GM BEDFORD REMOVAL ACTION SITE SOURCE CONTROL PLAN, ADDENDUM NO. 2

GM POWERTRAIN BEDFORD FACILITY BEDFORD, INDIANA

CONESTOGA-ROVERS & ASSOCIATES

**GM BEDFORD REMOVAL ACTION
 SITE SOURCE CONTROL PLAN**
 ADDENDUM NO. 2
 AREA NORTH OF AO14
 COLLECTION SYSTEM A PLAN AND PROFILE

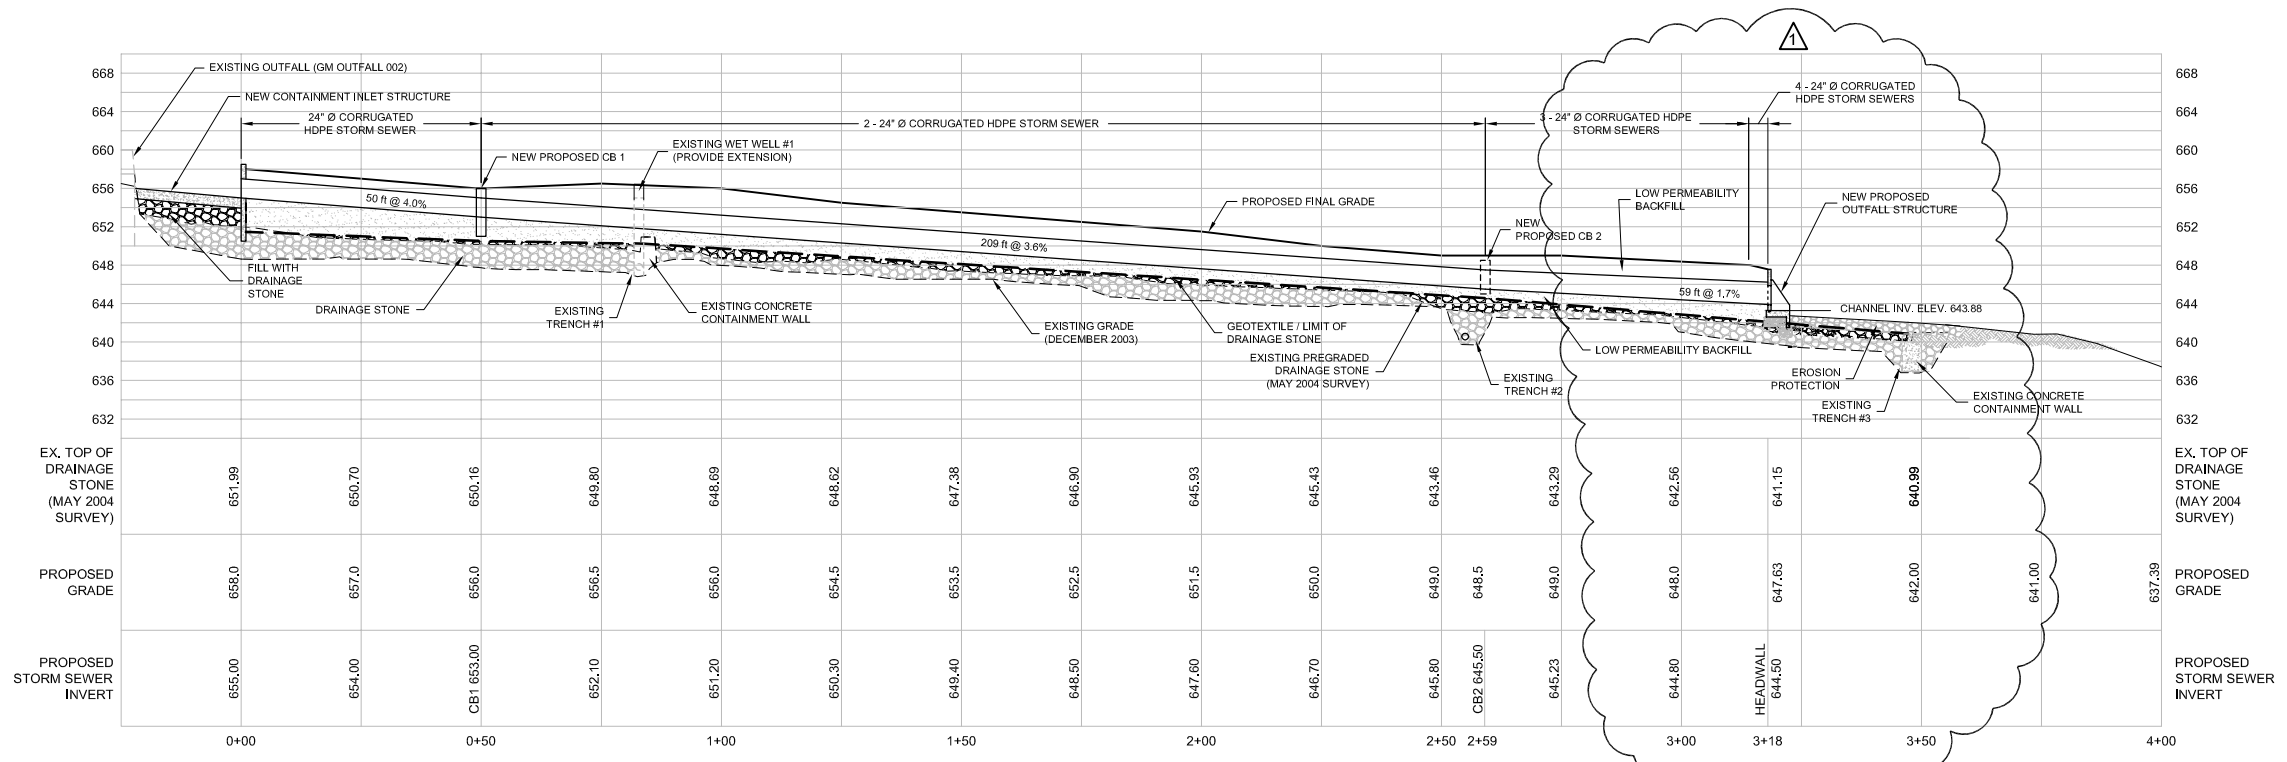
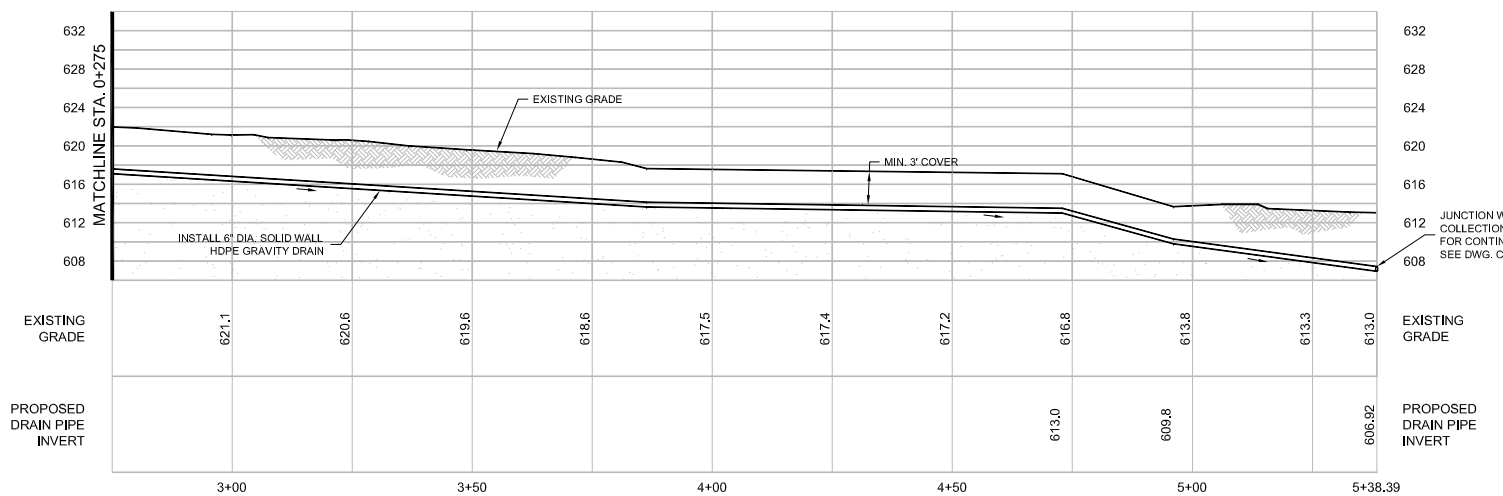
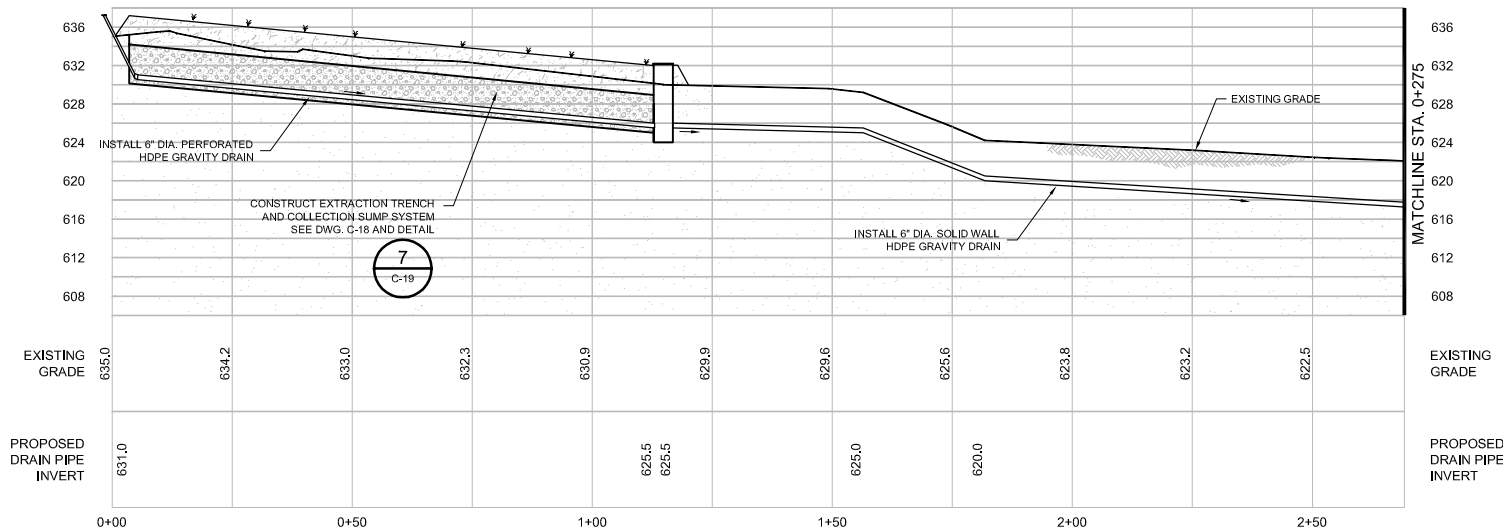
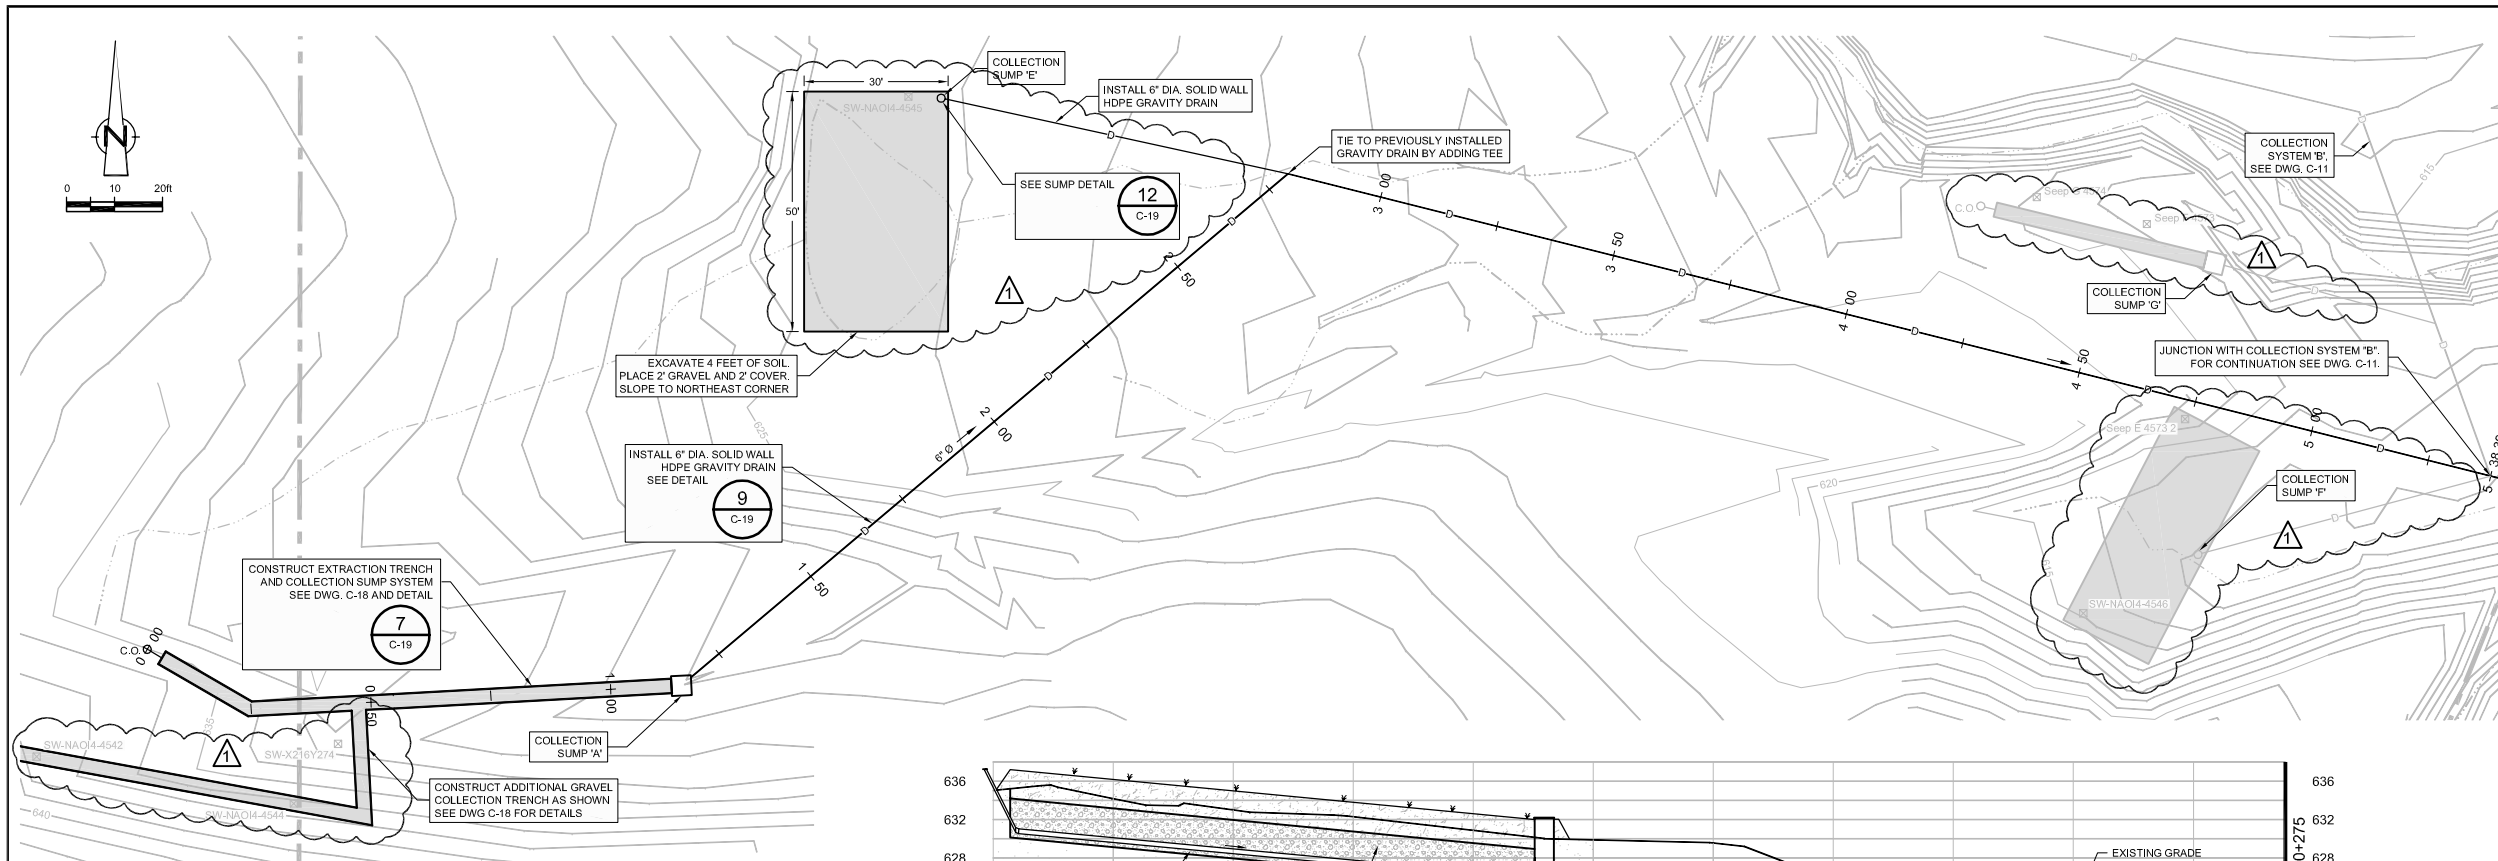
NO	Revision	Date	Initial
1	ADDITIONAL SEEP COLLECTION AREAS	OCT 18, 2004	CRH

**GM BEDFORD REMOVAL ACTION
SITE SOURCE CONTROL PLAN**
ADDENDUM NO. 2
AREA NORTH OF AO14
COLLECTION SYSTEM B PLAN AND PROFILE

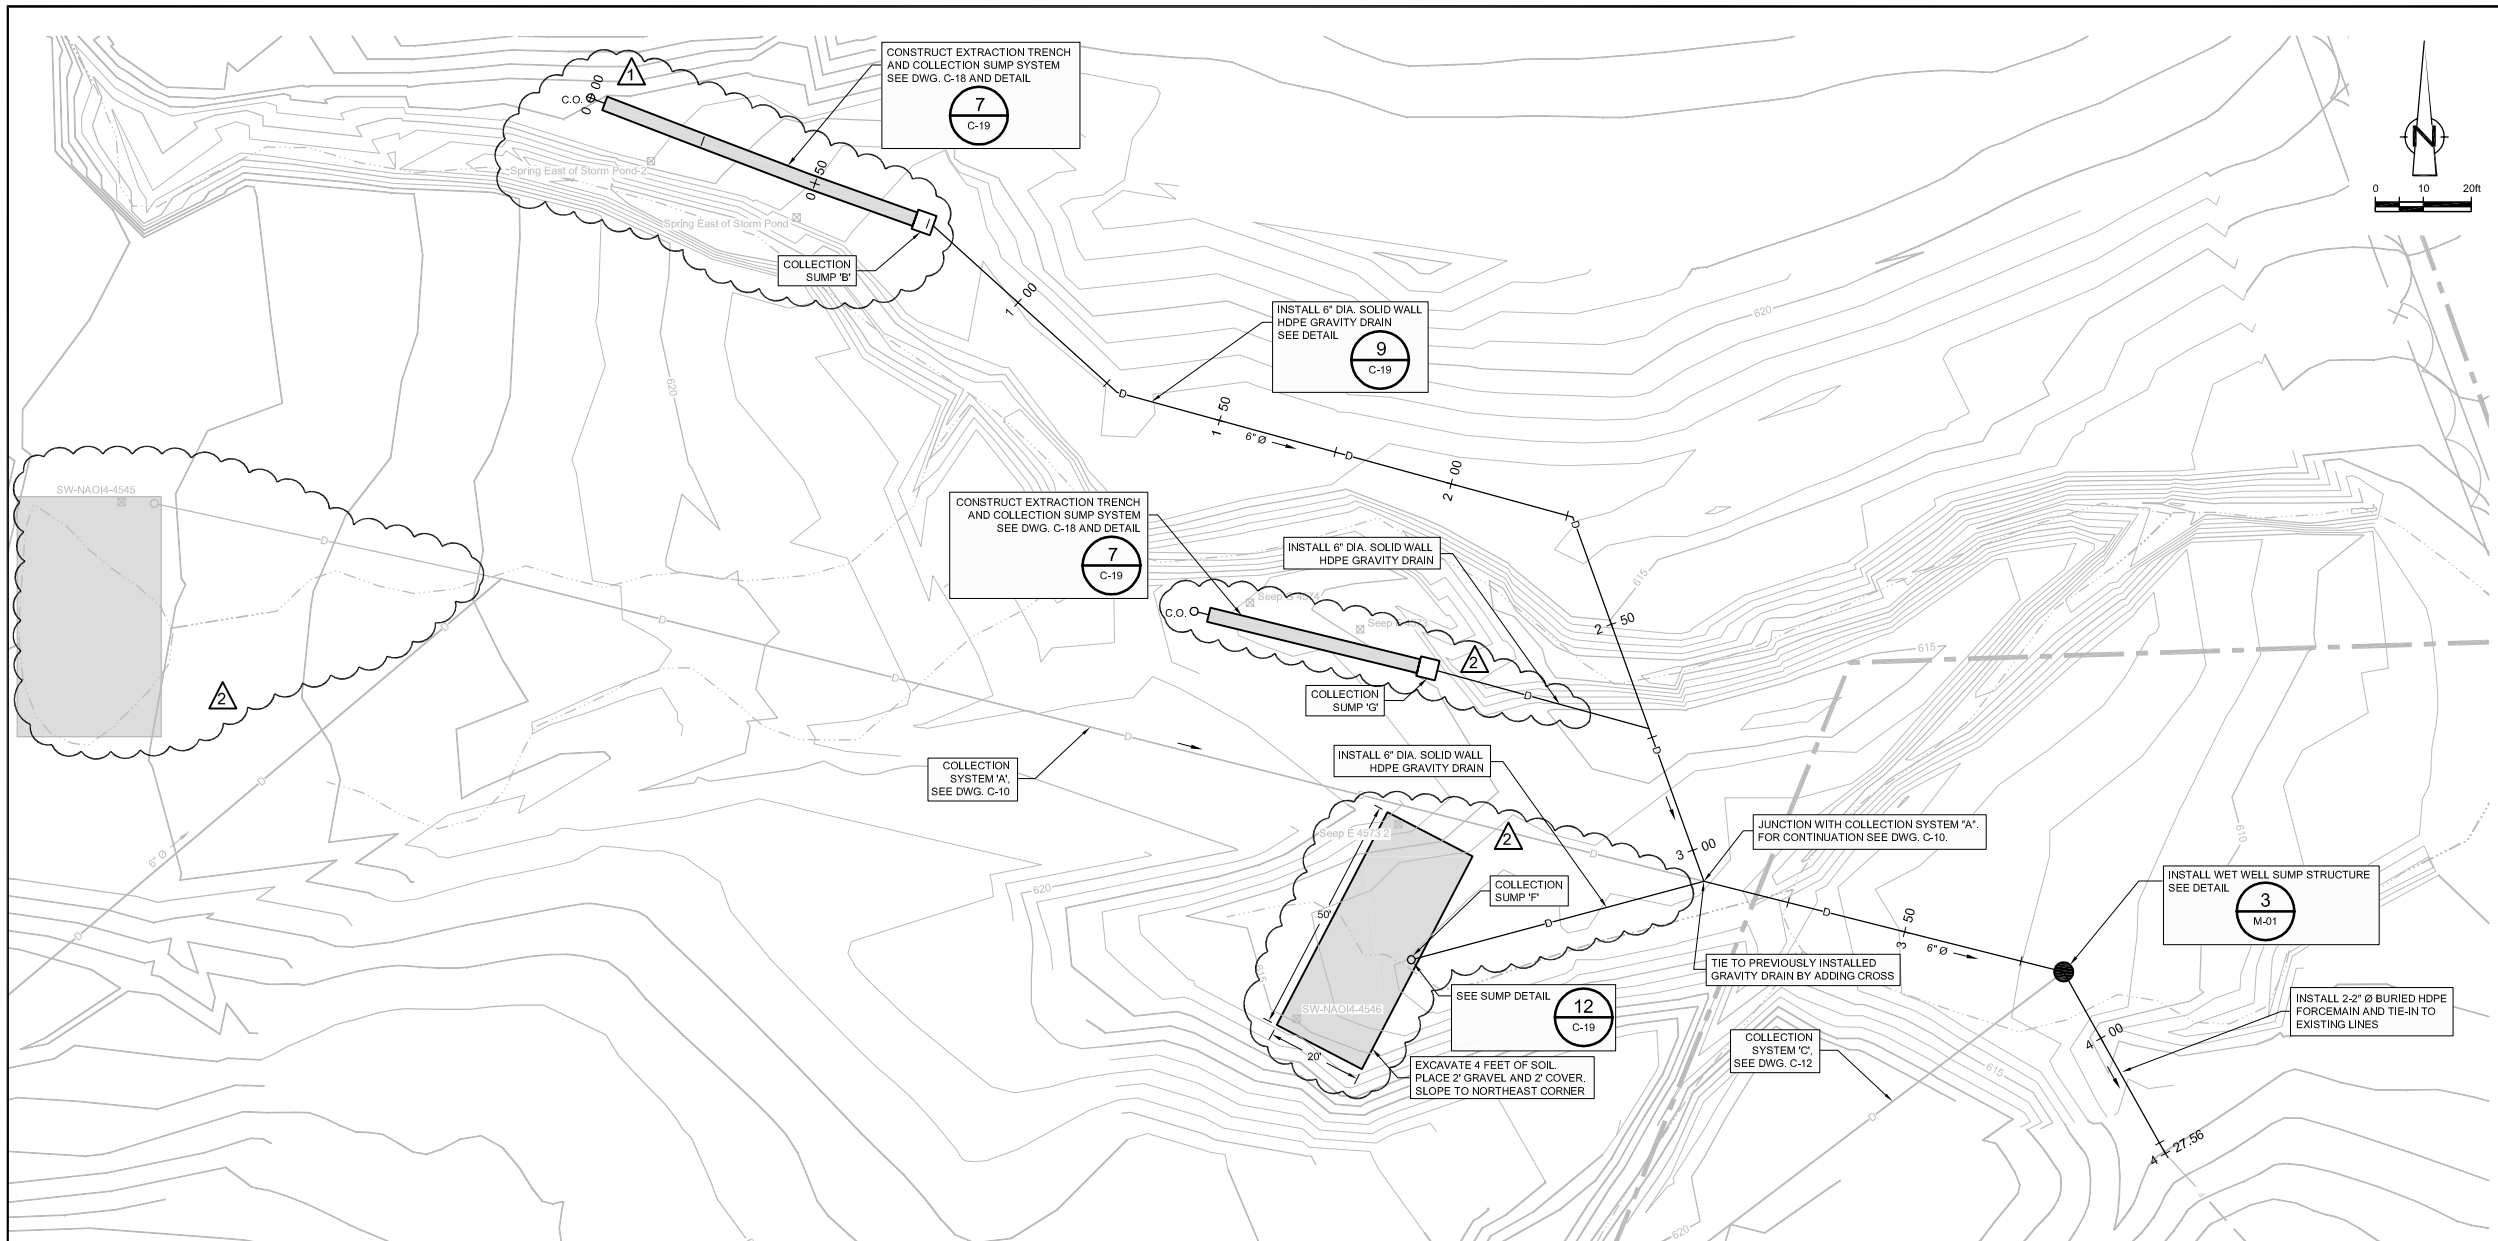
NO	Revision	Date	Initial
1	POSITION OF PROPOSED EXTRACTION TRENCH AND COLLECTION SYSTEM REVISED	AUG 20, 2004	AW
2	ADDITIONAL SEEP COLLECTION AREAS	OCT 18, 2004	CRH
